MONTGOMERY COUNTY HISTORIC PRESERVATION COMMISSION
STAFF REPORT

Address:	12 E. Lenox St., Chevy Chase	Meeting Date:	12/4/2019
Resource:	Contributing Resource Chevy Chase Village Historic District	Report Date:	11/27/2019
Applicant:	Justin and Elizabeth Bausch (Ben Van Dusen, Architect)	Public Notice:	11/20/2019
Review:	HAWP	Tax Credit:	n/a
Case Number:	35/13-19TT	Staff:	Dan Bruechert
PROPOSAL:	Porch Modifications

Figure 1: Photo of the house c.1910s showing its historic appearance.

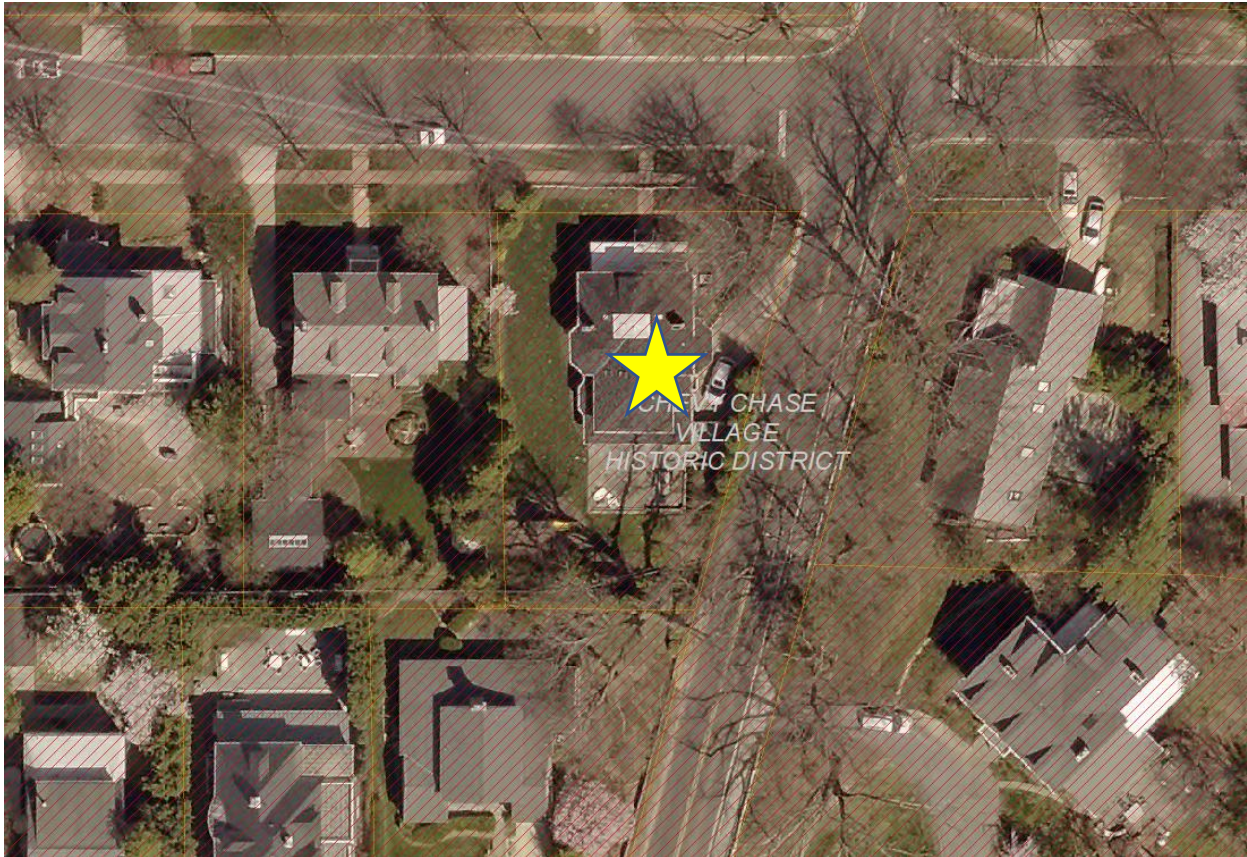
The original front porch had a bowed front with a brick wall and side-loading stairs. This configuration can be seen in the historic photo shown in Fig. 1 and Fig. 3. The porch columns had embellished bases and were supported by square pediments. The porch was changed to its current appearance sometime prior to 1927 (see the Sanborn Map in Fig. 3).

The existing columns are not original to the house, though their dimensions appear to be relatively consistent with the dimensions shown in the historic photograph (Fig. 1). The railing for the front porch aligns with the 24" (twenty-four inch) height of the pedestals. This dimension is a full 12" (twelve inches) lower than what is required by code. The applicant proposes replacing the existing columns and railings and replacing them with new wood columns and a traditionally designed wood railing. The property owner, the architect, and Staff worked through a number of design permutations to determine the best appearance for this new configuration (the designs can be seen in last page of the application). Three different design schemes were evaluated. Scheme A retained the columns and pedestals but installed new a code-complaint railing. This created the appearance of the top rail hanging 12" (twelve inches) in the air. Because this scheme retained the pedestals and columns Staff would have supported approval of Scheme A. Scheme B replaced the existing pedestals and installed new 36" (thirty-six inch) tall pedestals that matched the height of the new railing. Staff determined that enlarging the pedestals would shrink the column height and would make the porch appear 'squatter;' and did not find this to be as compatible as the other schemes. Scheme C, would install full-height columns with the 36" (thirty-six inch) railing engaged directly into the columns. Staff found that this scheme would best accentuate the vertical proportions of the porch while integrating the railing. Staff supports approval of the proposed replacement wood columns and railings shown in drawings 2, 3, and 4.

Above the porch, the applicant proposes installing a 28" (twenty-eight inch) tall wood balustrade, with pedestals spaced above the porch columns. The historic photograph, Fig. 1, shows that there was a historic balustrade in this location. The original balustrade had some type of corner finial (possibly be pinecones or acorns or urns), but there isn't sufficient detail to make a determination. This balustrade was

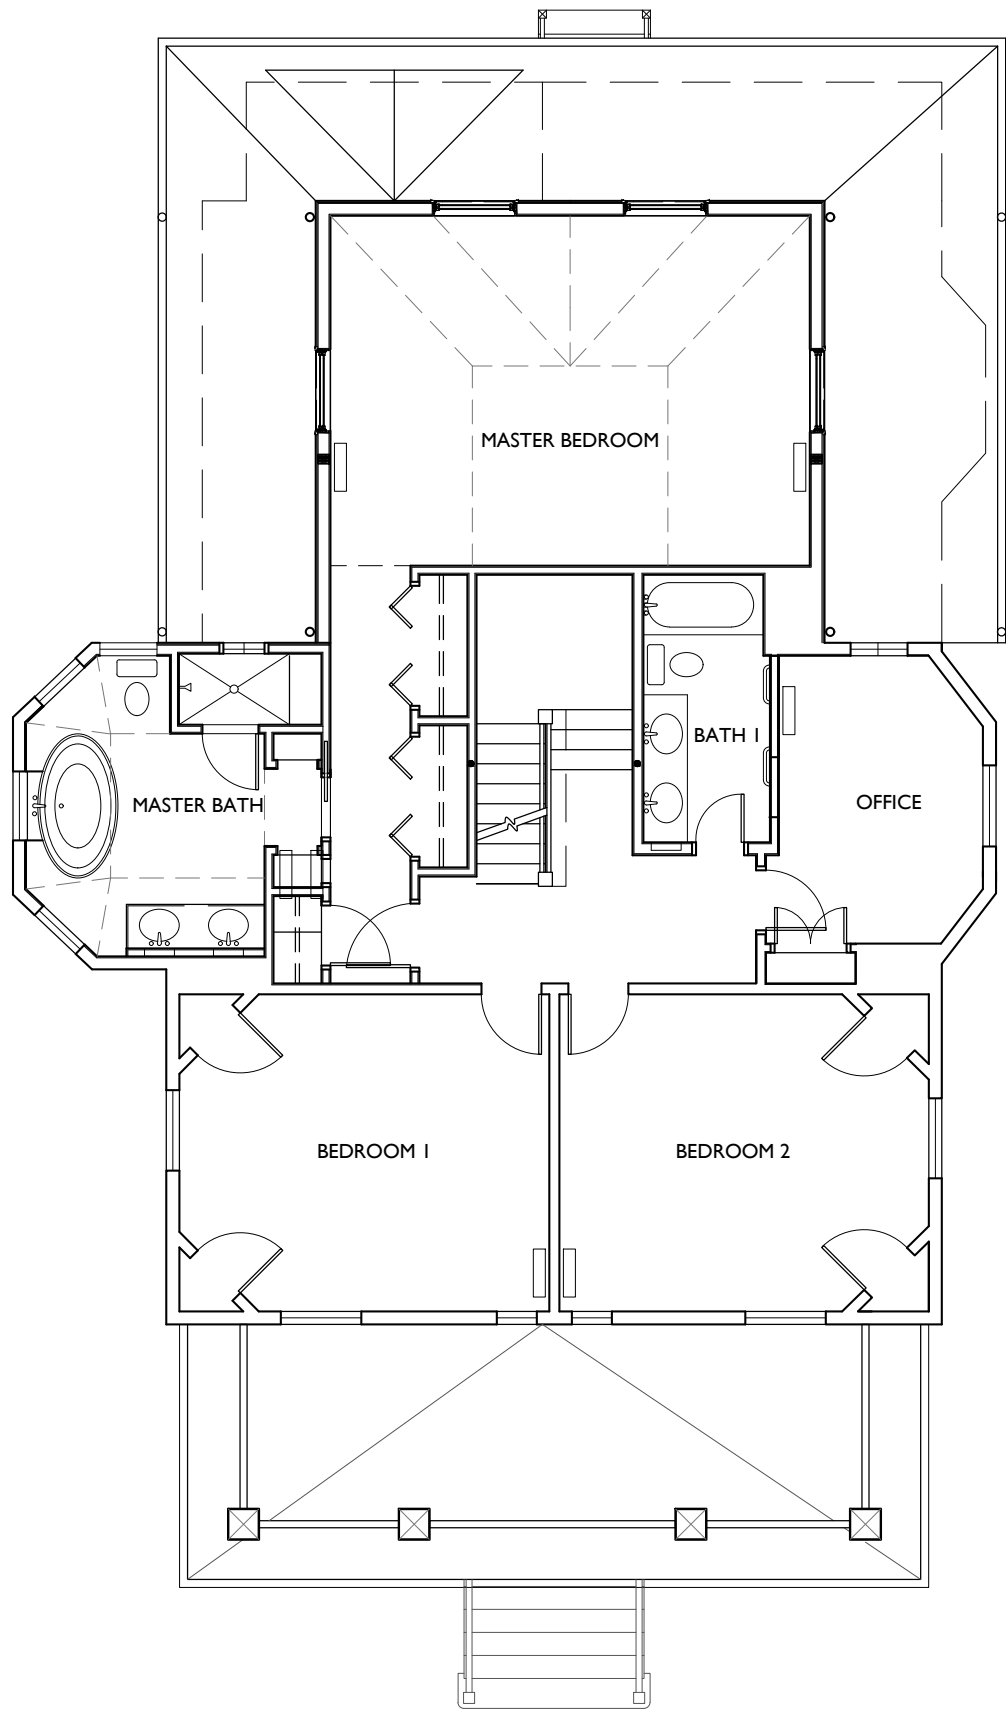
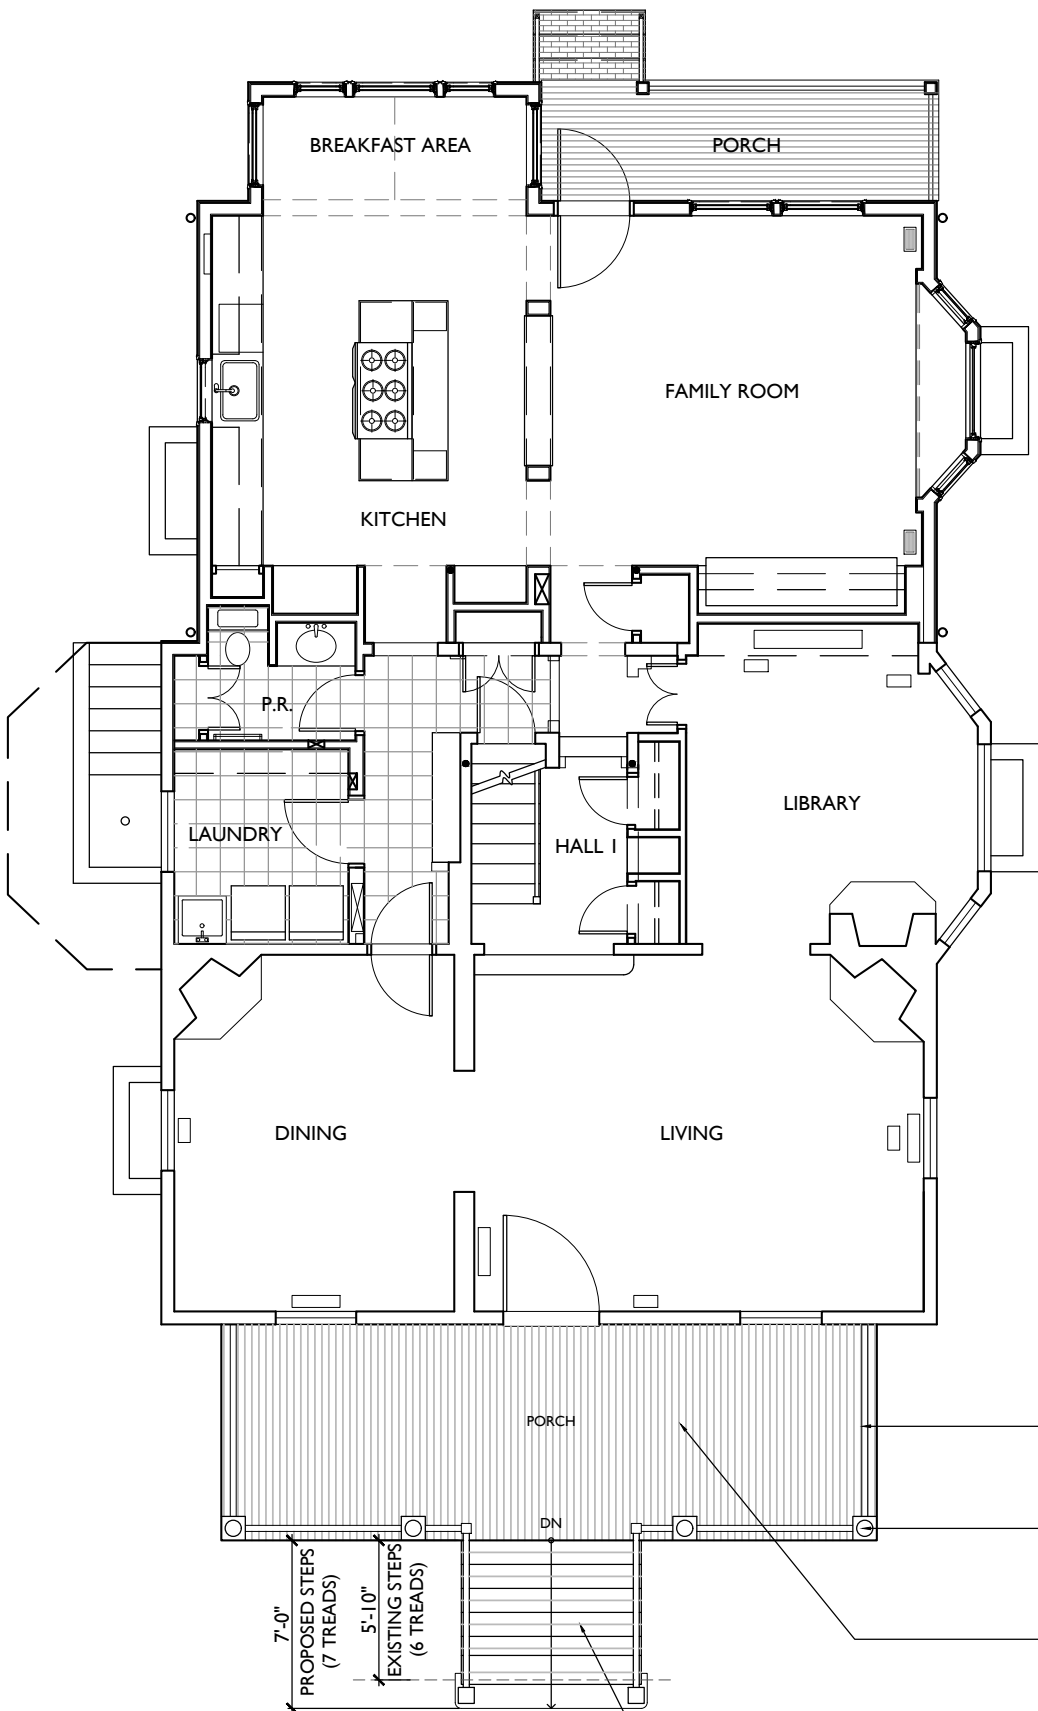
The existing front porch steps are wood and are too steep to meet current code. The applicant proposes a new set of code-compliant steps, which will add an additional riser and will project an additional 1' (one foot) into the front yard. The applicant proposes to construct the stair risers and treads in Azek composite. The first step will be constructed out of brick to match the existing porch piers. The applicant proposes to install new full-height, wood ionic columns in place of the existing wood tapered columns on wood pedestals. The column spacing will match the current configuration. The last proposed change is the replacement of the existing wood railing with a code-compliant wood railing in the porch and a balustrade above. Staff finds the proposed work is compatible with the Chapter 24A and the *Design Guidelines* and recommends approval.

Staff finds that as the existing steps are not original to the house, they may be removed and replaced. Staff finds the current configuration is appropriate to the character of the house and the extension of the stairs by 1' (one foot) will not substantially alter the appearance of the house. The applicant proposes to remove the wood in the stairs and porch decking and replace them with Azek composite. Azek is millable and paintable and has been approved in limited circumstances in the Chevy Chase Village Historic District. Usually, these materials have been allowed for trim work or elements where the visual character is paramount, and the physical characteristics are less important. In this instance, the treads, risers, and decking are evaluated for their visual *and* physical character, because they will be touched on a regular basis. Staff does not find Azek to be physically compatible with wood due to its inability to wear and develop a patina. Staff recommends the HPC add a condition for approval that the stair risers, tread, and decking needs to be wood which would be compatible with 24A-8(b)(2). Staff recommends the HPC delegates final approval authority to Staff to determine this condition has been met.

1. The stair risers, treads, and decking need to be constructed out of wood. The HPC delegates final approval authority to Staff to confirm this condition has been met.
